Marin County Flood Control and Water
Conservation District
**Corte Madera Creek Flood Risk Management
Project, Phase 1**
Final Environmental Impact Report
Volume 1: Comments and Responses to Comments
State Clearinghouse No. 2020080353

**Marin County Flood Control and Water
Conservation District
Corte Madera Creek Flood Risk Management
Project, Phase 1
Final Environmental Impact Report
Volume 1: Comments and Responses to Comments
State Clearinghouse No. 2020080353**

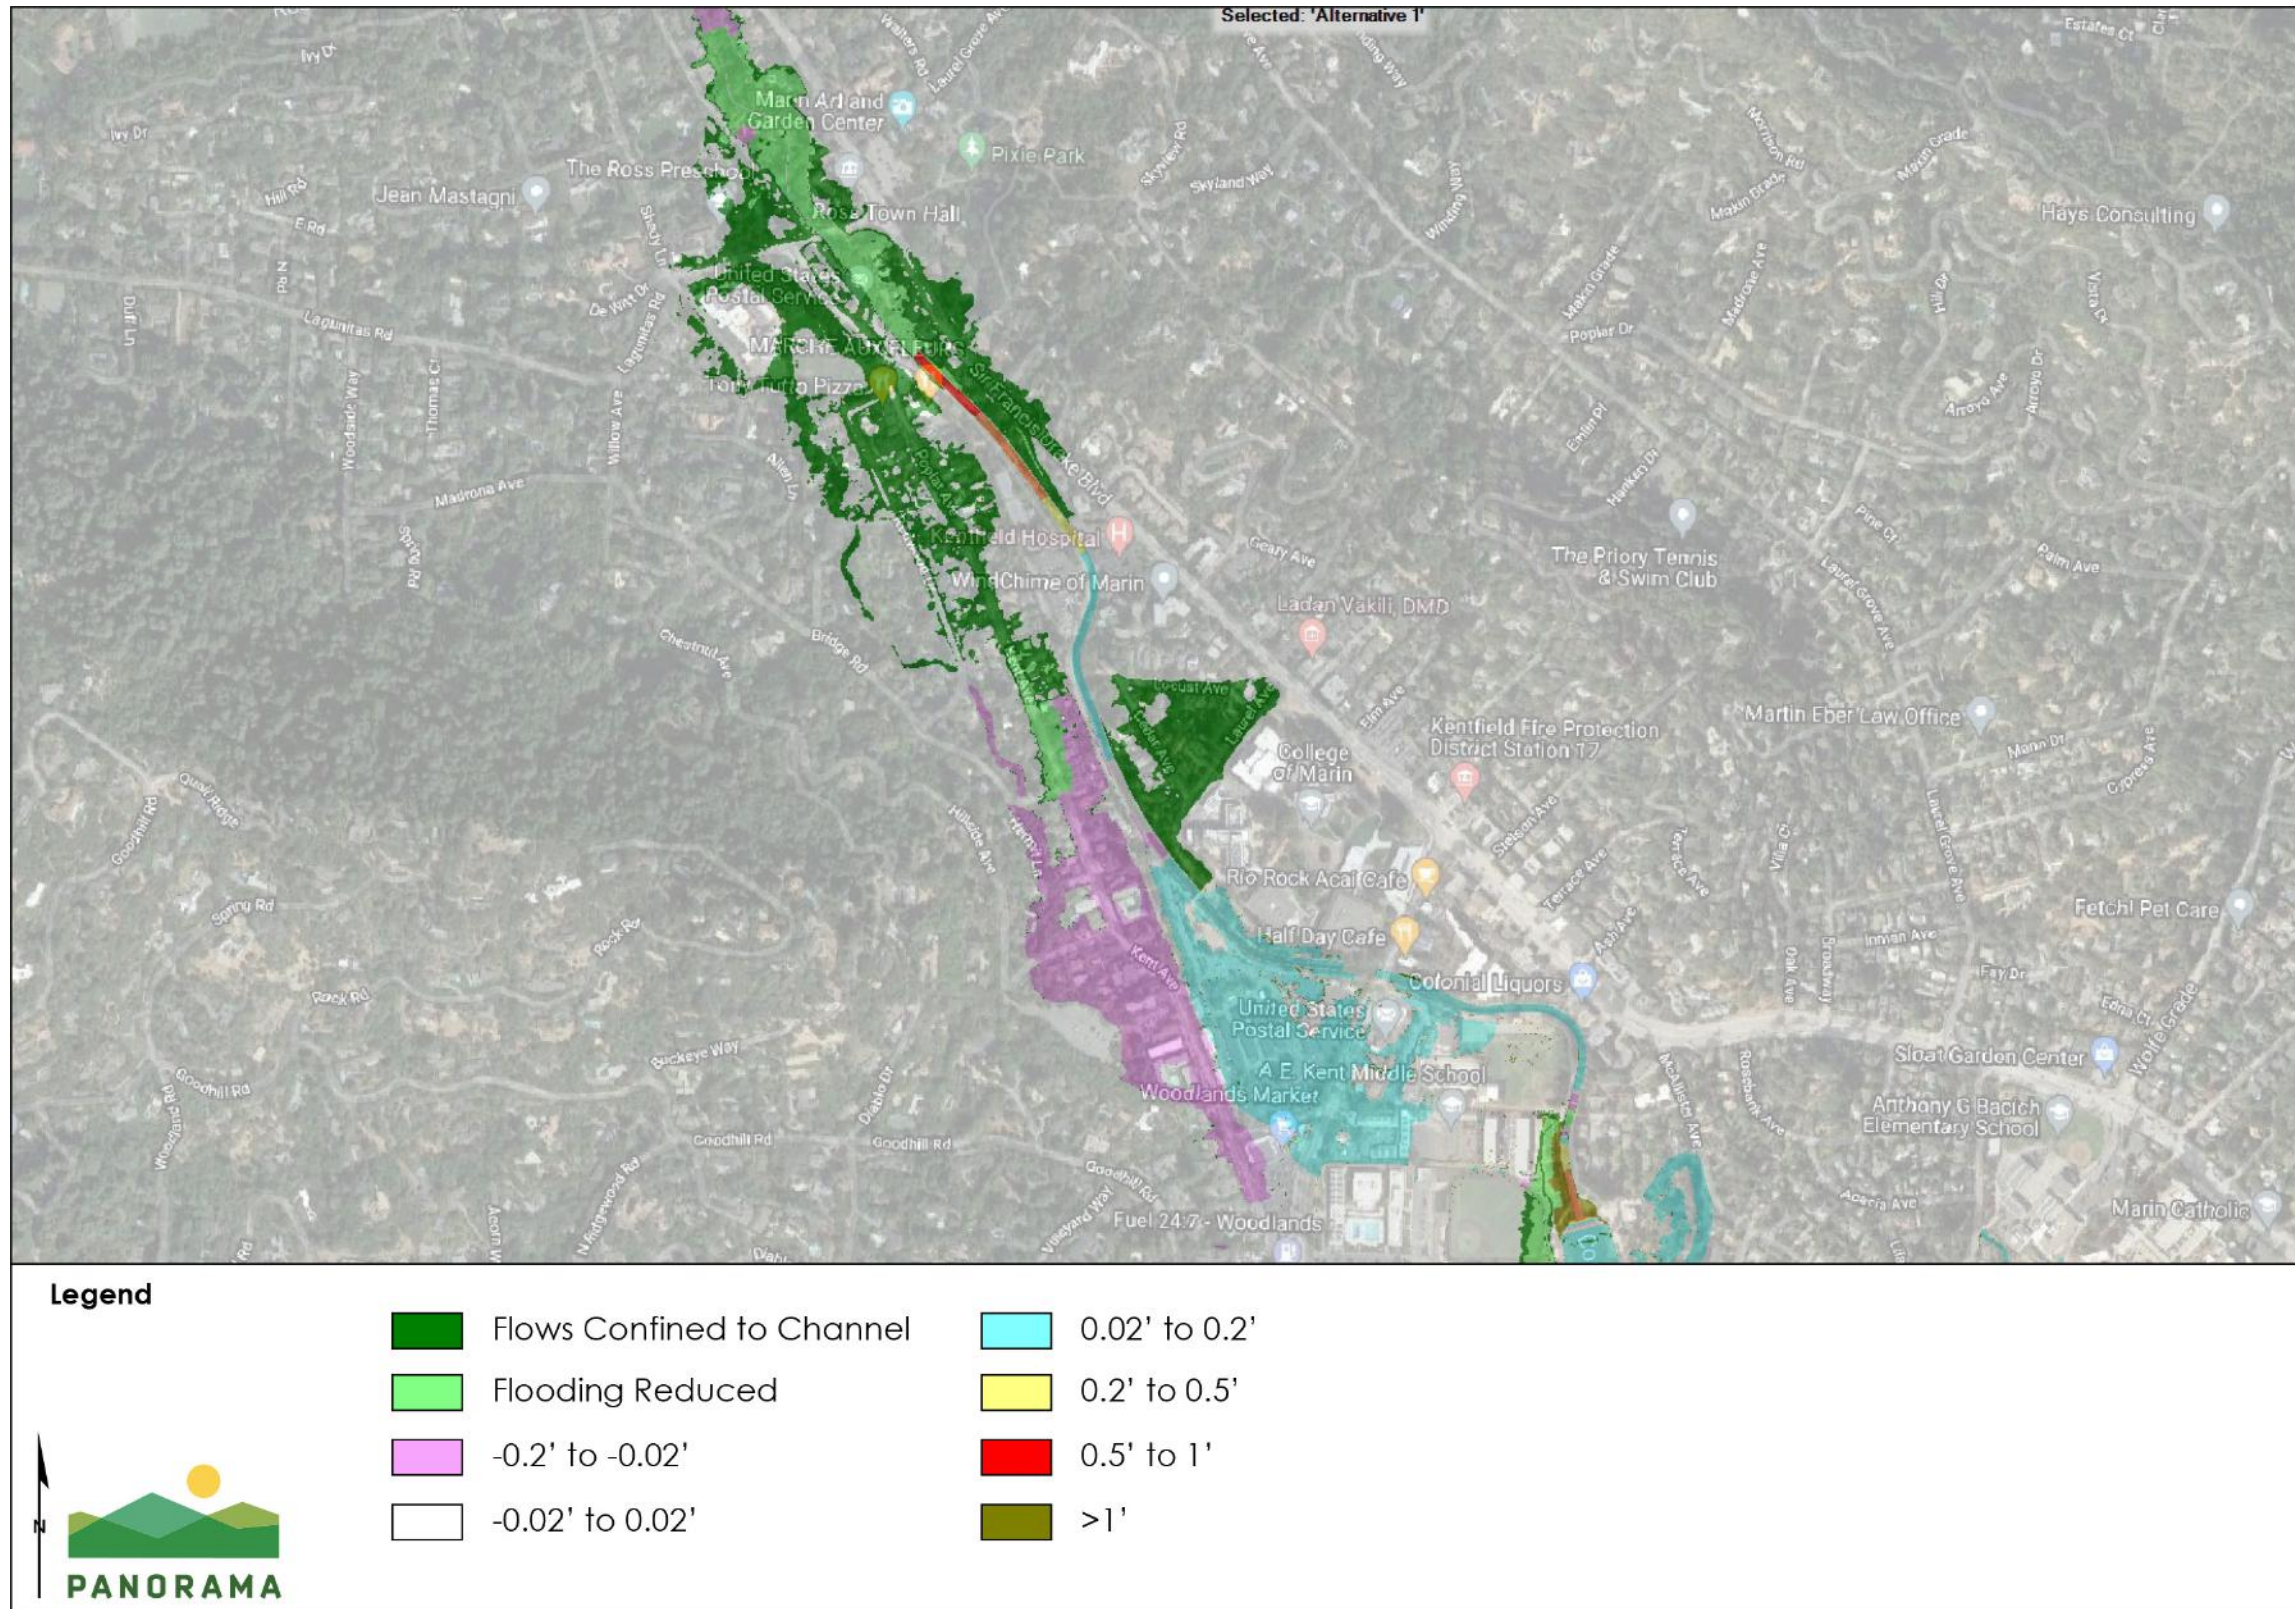
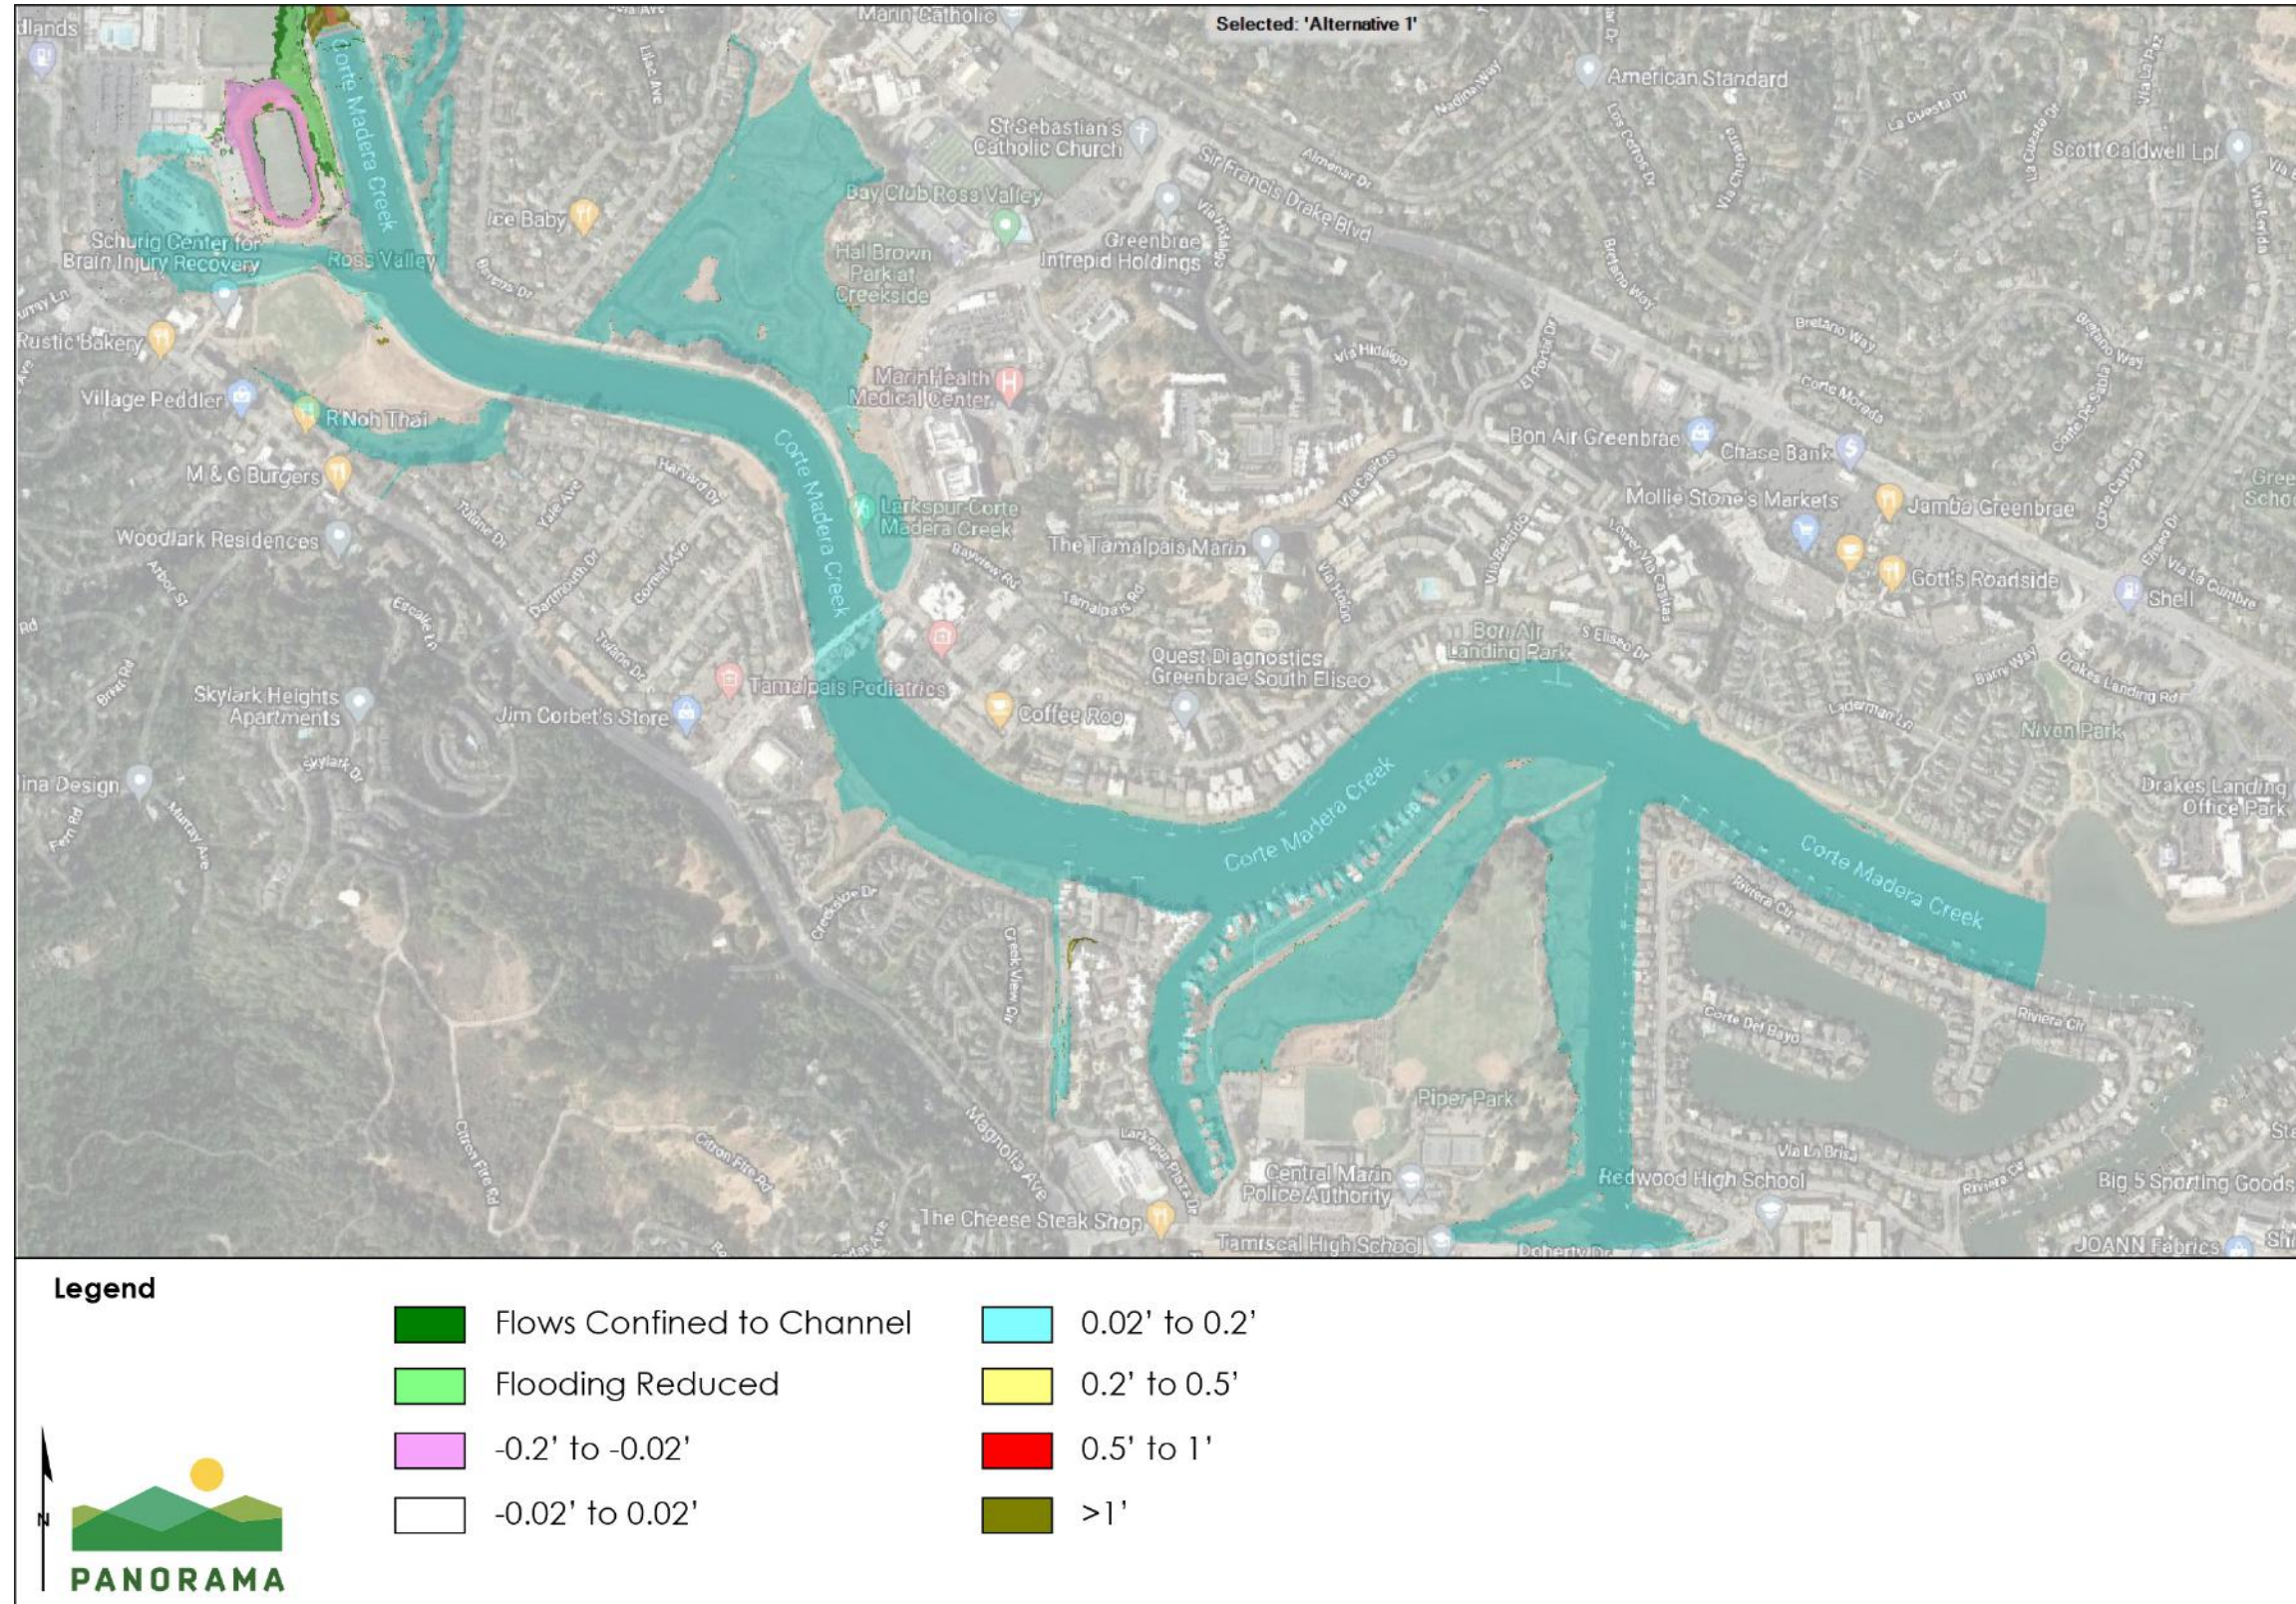
The geographic extent of the figures showing the changes in WSE differs from the figures included in the Draft EIR. The geographic extent of the figures was expanded to show areas downstream from Unit 2 in response to comments from the City of Larkspur. As discussed on page 3.9-39 in the Draft EIR, a threshold of 0.2 foot (2.4 inches) was used for determining whether a potentially significant increase or decrease in WSE would occur at any structure. The 0.2-foot threshold is a reasonable level of precision for evaluating flooding impacts, considering the standards for accuracy and precision associated with hydraulic modeling.

Figure 2-1 through Figure 2-6 show the Alternative 1 changes to the WSE and reflect the difference in WSE between the Existing Condition Without Project and Existing Condition With Alternative 1 scenarios under a 10-, 25-, and 100-year flood, using the updated modeling for the 60 percent design. Figure 2-7 through Figure 2-12 show the Alternative 1 changes to the WSE under for the future condition scenario, and reflect the difference in WSE between the Future Condition Without Project and Future Condition With Alternative 1 under the 10-, 25-, and 100-year flood conditions. The assumptions used in the future condition modeling are described on pages 3.9-35 through 3.9-37 in Section 3.9 in the Draft EIR and are supplemented by the model updates described above. Figure 2-13 through Figure 2-18 show the Alternative 1 changes to the WSE under a “high-emissions likely” sea-level rise scenario, to reflect 2100 projected sea-level rise based on the 2018 Update of the State of California Sea-Level Rise Guidance (California Ocean Protection Council, 2018). Figures 2-13 through 2-18 reflect the difference in WSE between the Year 2100 Future Condition Without Project and Year 2100 Future Condition with Alternative 1 scenarios under the 10-,25-, and 100-year flood conditions.

Areas shown in the figures as “Flows Confined to Channel” are areas that are currently flooded by Corte Madera Creek, which are predicted to no longer have flood inundation from Corte Madera Creek overtopping after Alternative 1 is implemented. Areas shown in the figures with “Flooding Reduced” are areas with reduced flood inundation (greater than 0.2 foot) from creek overtopping after Alternative 1 is implemented. The change in WSE shown on the maps reflects a comparison between WSE without implementation of Alternative 1 and the WSE after implementation of Alternative 1 for each modeled scenario.
